**RPA East Gas Compound  
Report of Compliance Audit  
Required by  
Development SSD-47662959  
Condition B44 26 June 2024**

**For  
CPB Contractors**

**Prepared by: Whamcorp Pty Ltd**

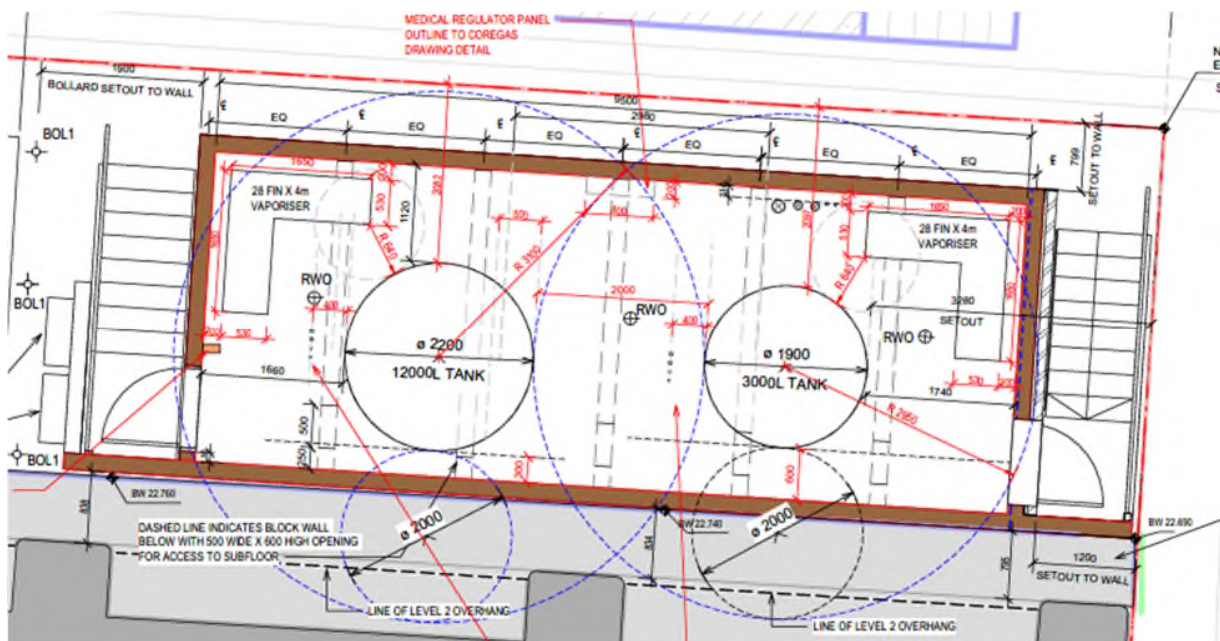
There is limited space between the Centenary Institute and the property boundary. The marked up plan below shows the tanks and the 2m Safety Distance “D”.

It also shows screen walls on all sides as the required separation of 4m distance around potential leak or spillage points in the bottom part of the tank cannot be achieved without screen walls, as detailed below.

Note that the distances between the tanks and the walls are at the minimum permissible for access and allowance for separation from other equipment

The installation has been located close to the Centenary Institute in order to achieve the 2m separation distance from the boundary (shown in red) applicable to the upper part of the tank where the Safety Limit "S" does not apply and only the Safety Distance "D" applies.

This results in a screen wall on the south (Centenary Institute) side of height matching the tank height, but does not require that height on the other sides.

The alternative of moving the whole installation to the north to achieve 2m separation of the tanks from the building would require the screen wall on the north side to be of a height matching the tank height. Having consideration of external visual appearance (e.g. Condition B45), this option was rejected.
